Re: #13ITB87339K-LW, Juvenile Court Building Entrance Security Renovation

Attached is one (1) copy of Addendum #2, hereby made a part of the above referenced Invitation to Bid (ITB).

This Addendum forms a part of the contract documents and **modifies** the original ITB documents as noted below:

DRAWING #
A-1.2
DATE: 6-11-12

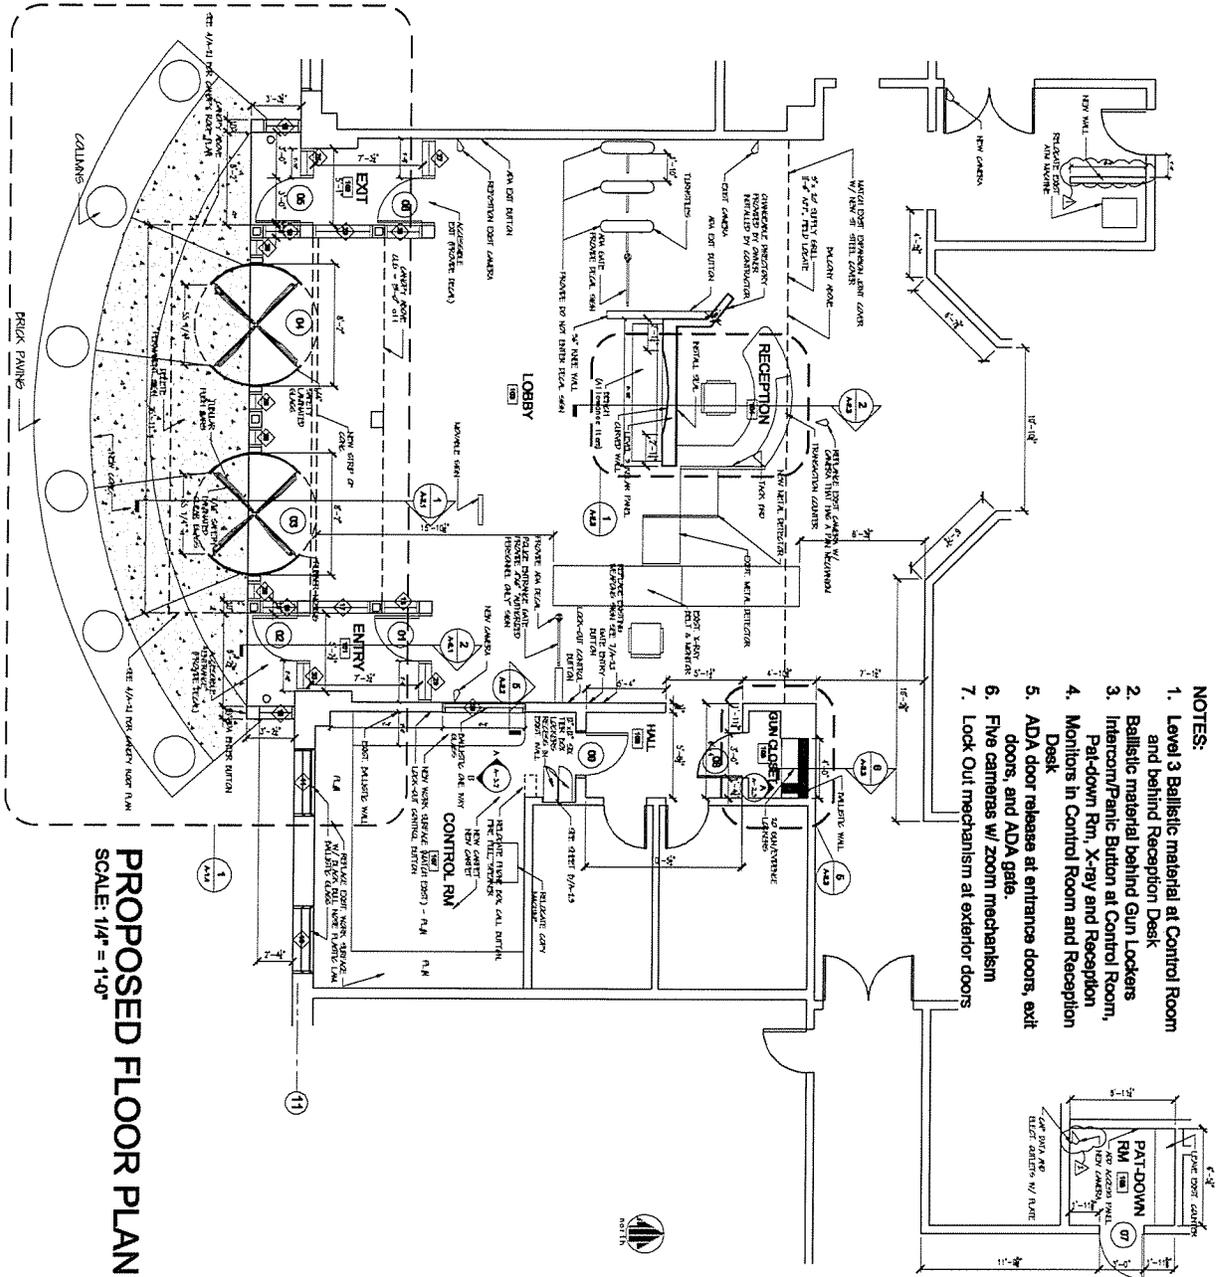
Q7: Will a camera be required in the pat down room?

Q14: On drawing A-1,2 indicates the camera closest to the reception desk should be replaced with a camera that has a pan mechanism. Note 6 on the same page mentions Five cameras w/zoom mechanism. Does this camera require tilt and zoom functions also?

Rev.	Description	Date
1	Add Camera Location - Rm	4-2-12
2	Add Privacy Wall - ATV Room	4-5-12
	See Drawing Descriptions

A7: Yes. A camera will be required for Room 108.

A14: This scope of work will be under a separate contract.

DRAWING # **E-1.1**

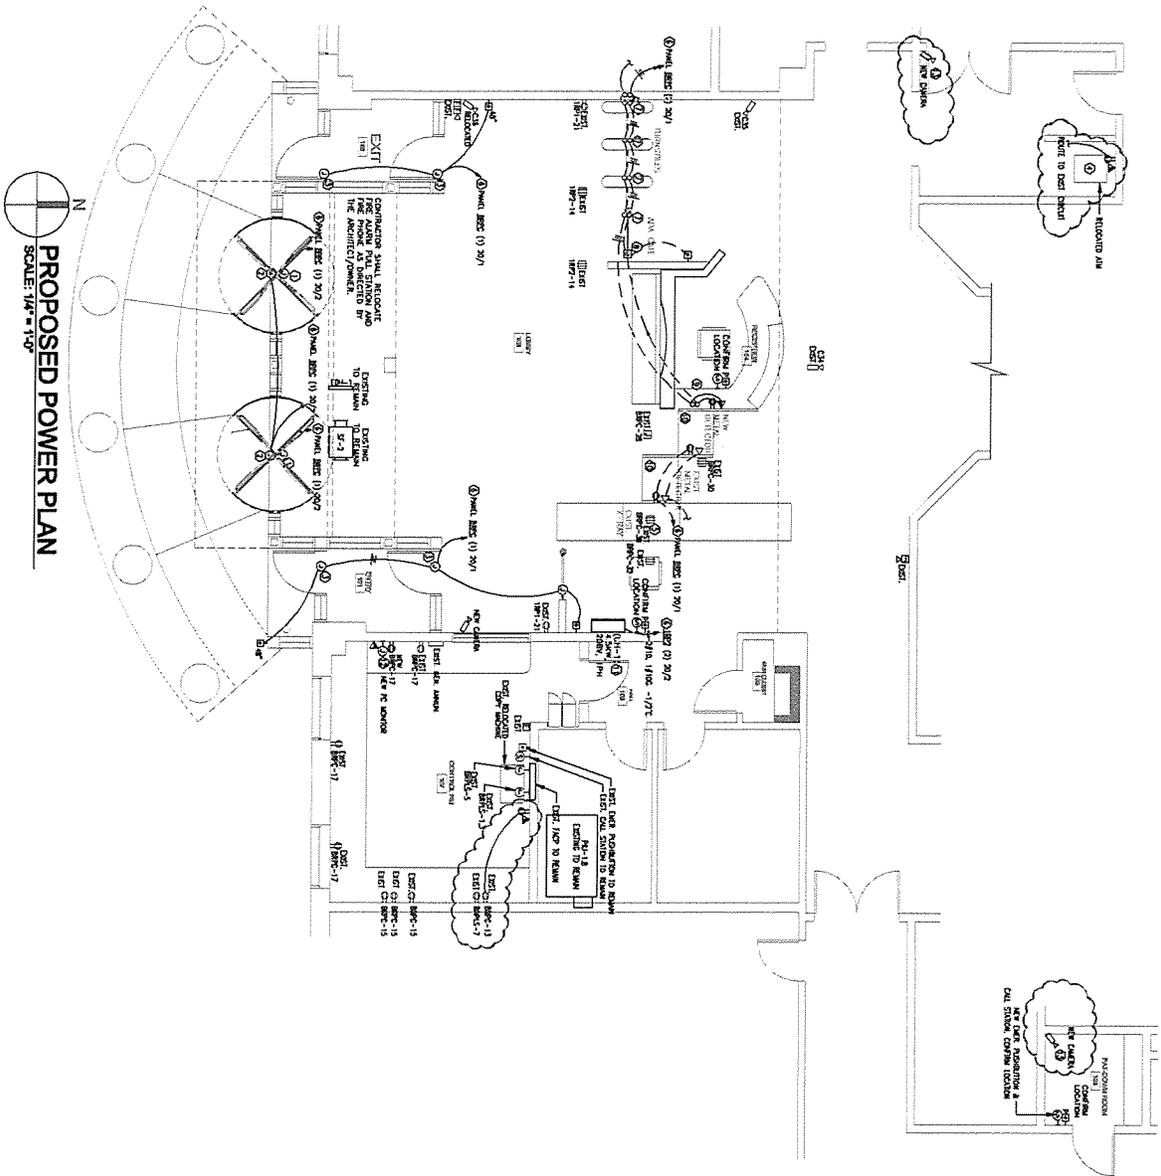
Q23: Provide specification for camera.

- A23: Cameras will be under a separate contract. All identified new camera locations will require the contractor to provide data pulls ONLY. Power is not required unless there are Ptz (Pan tilt zoom) cameras. The actual data will be pulled by in house contractors. Note: Raceway is required where necessary, which is typically where drop ceilings are not in the path of the complete cable run. A pull string in any raceway is required
